# **PowerPC™**

## **Errata to MPC603e & EC603e Microprocessor User's Manual, rev. 1**

This errata describes corrections to the *MPC603e & EC603e RISC Microprocessor User's Manual*. For convenience, the section number and page number of the errata item in the user's manual are provided.

Figure 5-8. Page Address Translation Flow—TLB Hit

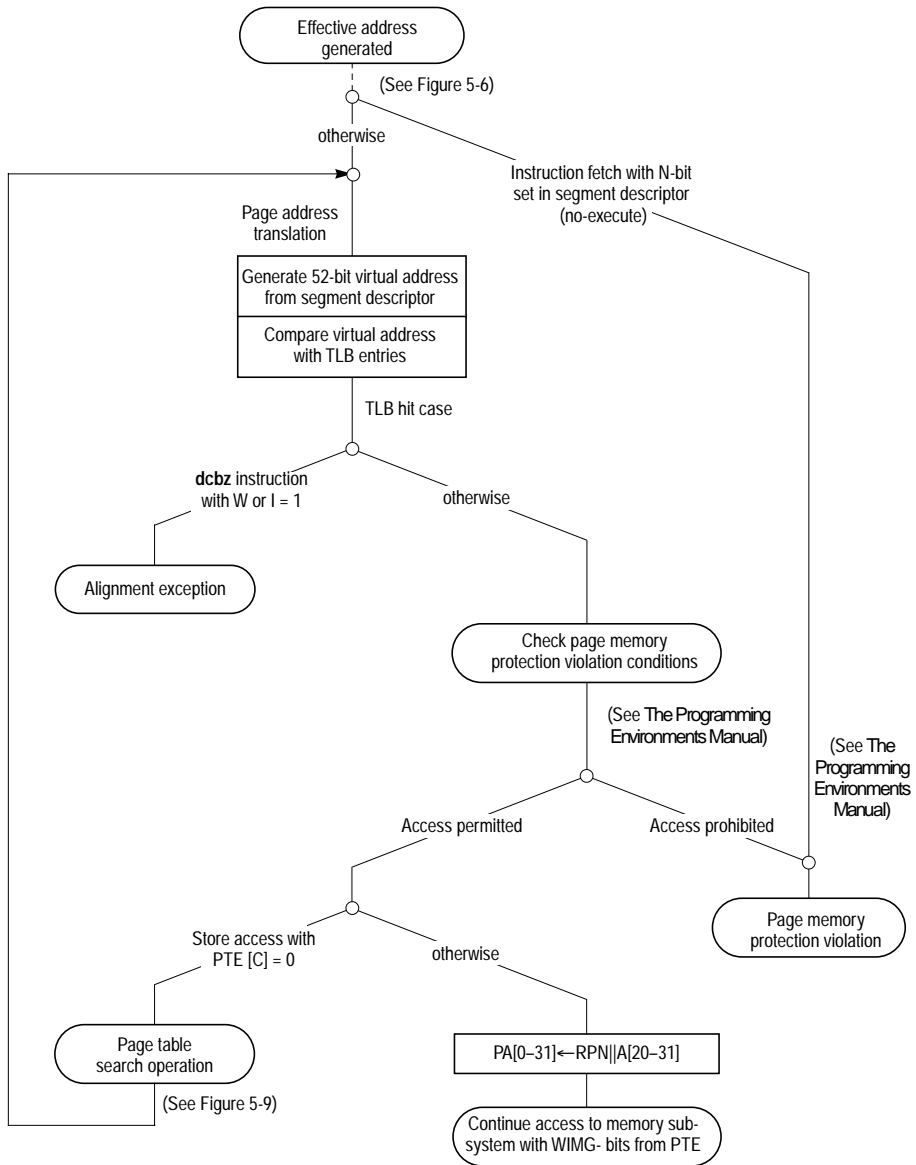
- 5.4.4, 5-29      Figure 5-8 in the published manual incorrectly shows the loopback arrow on the left side pointing to the node above the word ‘otherwise’. Replace Figure 5-8 with the following:
